Connecticut 2034 Needs Assessment - Revision 1 Correction

Revision to the March 19, 2025 Presentation

Correction to the July 23, 2025 Presentation

Revised Eastern CT / Southwestern RI Pocket Violations

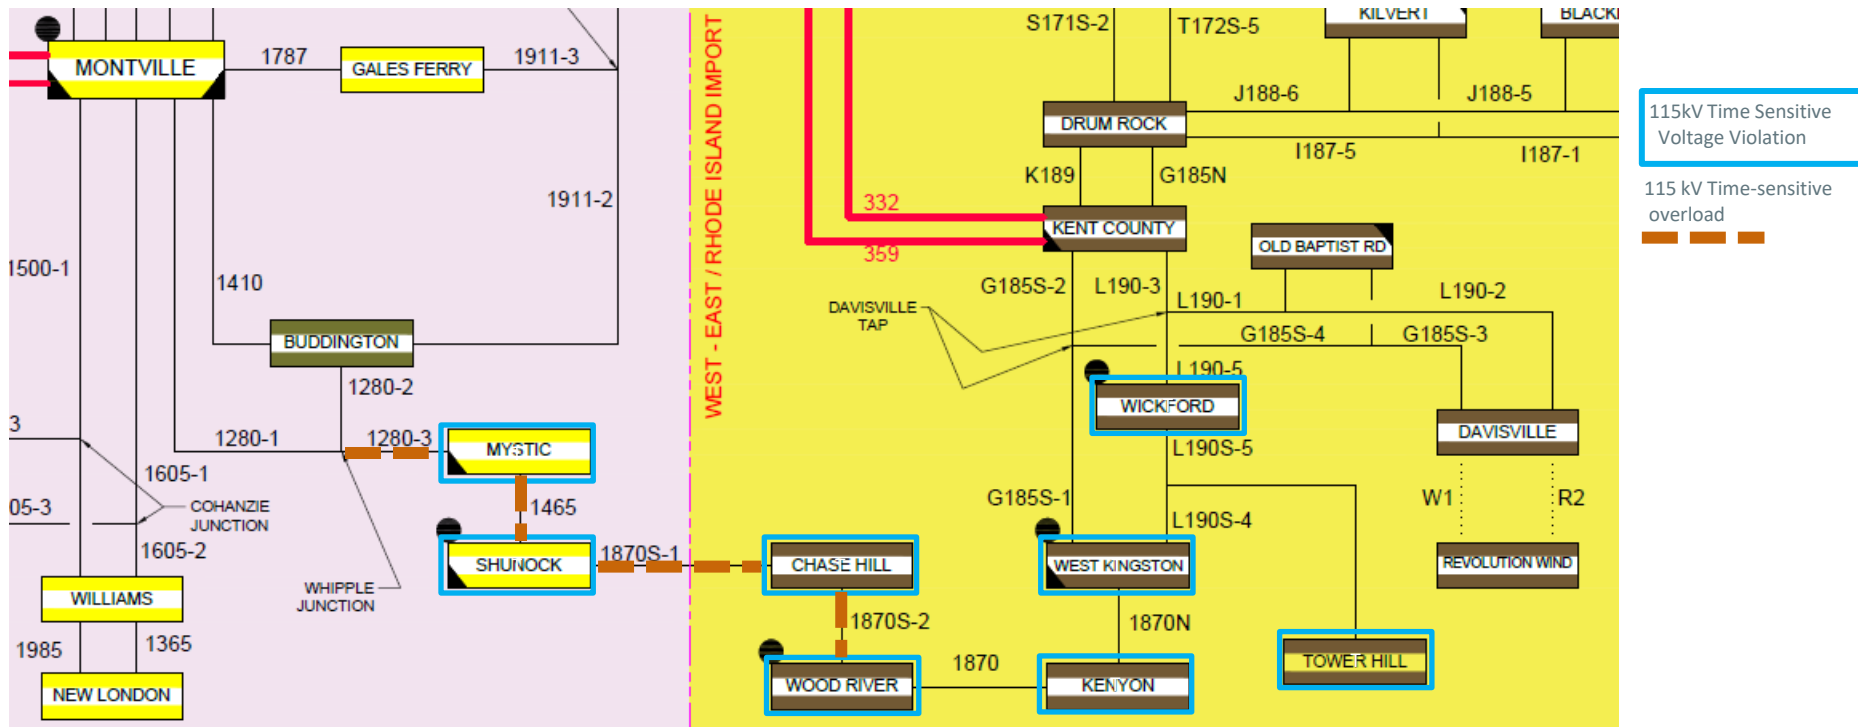
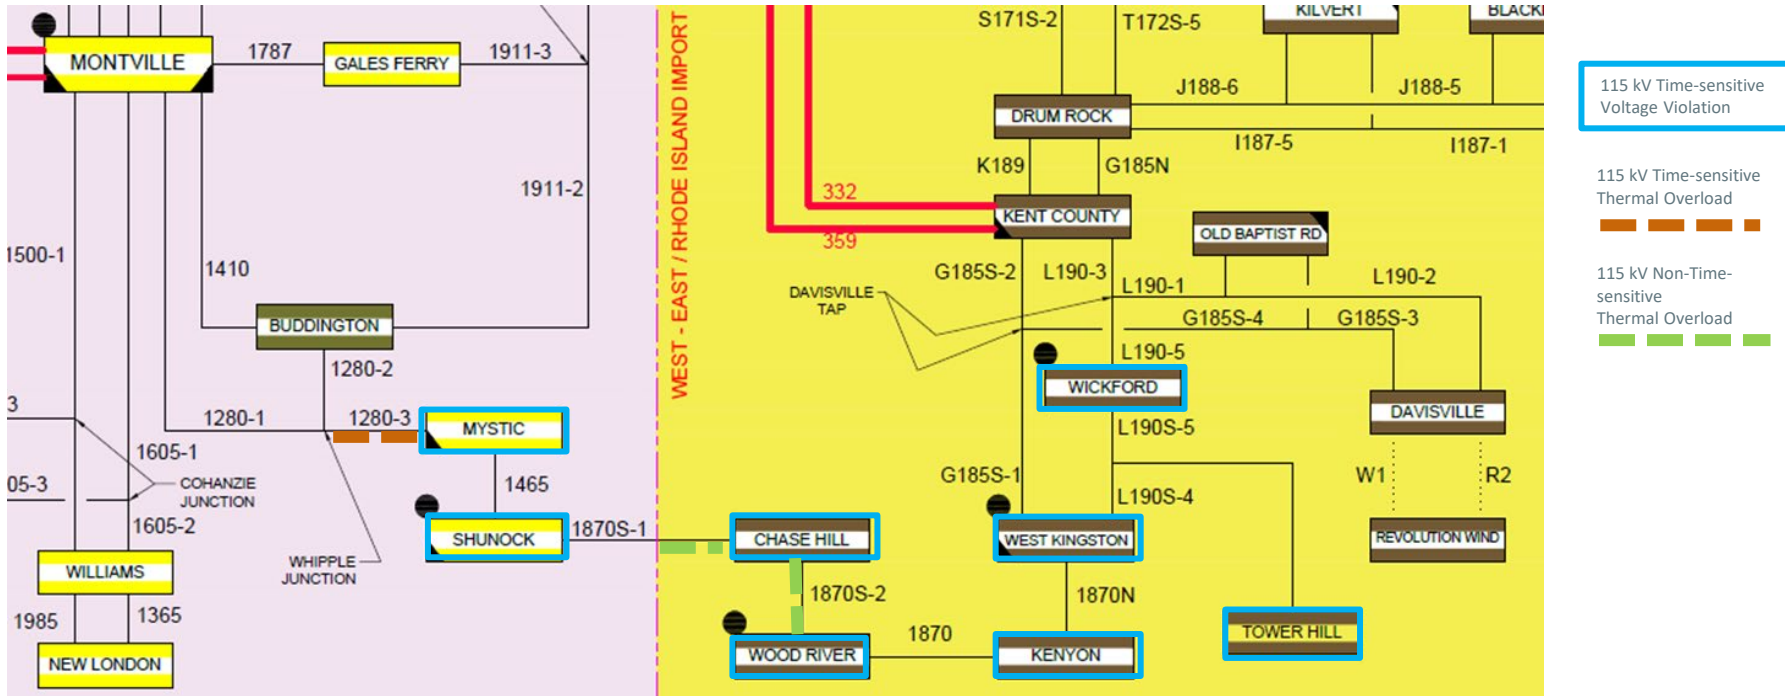
- All violations occur near the ECT/SWRI border
 - Out of the 3 115 kV elements with N-1 and N-1-1 thermal violations, one element is identified as a time-sensitive need as it was observed in the time sensitive year of 2028

- Out of the 12 115 kV buses with low voltage violations, ten buses are identified as a time sensitive need as it was observed in the time sensitive year of 2028

- The 1080-1 line between Card and Wawecus Junction Tap was observed to be a thermal violation in the Draft Connecticut 2034 NA report and the ISO identified the line as a candidate for an NPCC D1 exclusion. However, the results of the Draft Connecticut 2034 NA – Revision 1 report shows the LTE loading on the 1080-1 line at 99.9% and therefore is no longer considered a thermal overload

Five Three Thermal Overloads

Line 1080 Overload

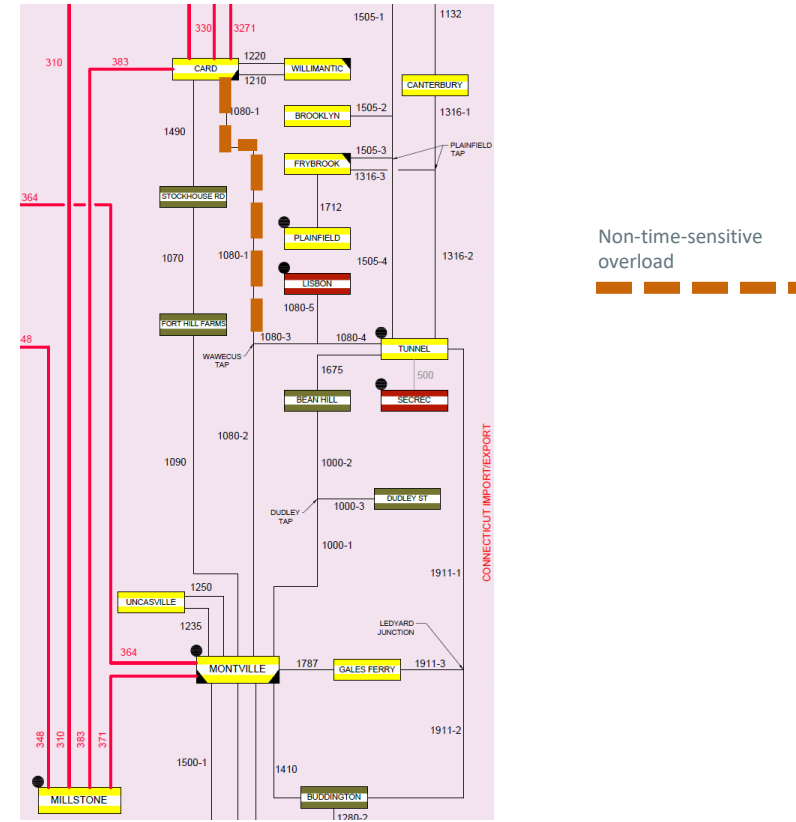
- The CT 2034 Needs Assessment identified an N-1-1 thermal overload on the 1080-1 line between Card and Wawecus Junction Tap
 - Loading in 2034 – 101.5 %
 - Loading in 2027 – 98.4 %
- This overload only shows up for one contingency pair, where the second contingency is a multiple-element contingency (breaker failure)
 - Of the various transmission planning criteria, NERC TPL-001, ISO-NE PP3 and NPGC Directory 1, only Directory 1 requires the evaluation of multi-element contingencies as second contingencies for N-1-1 testing
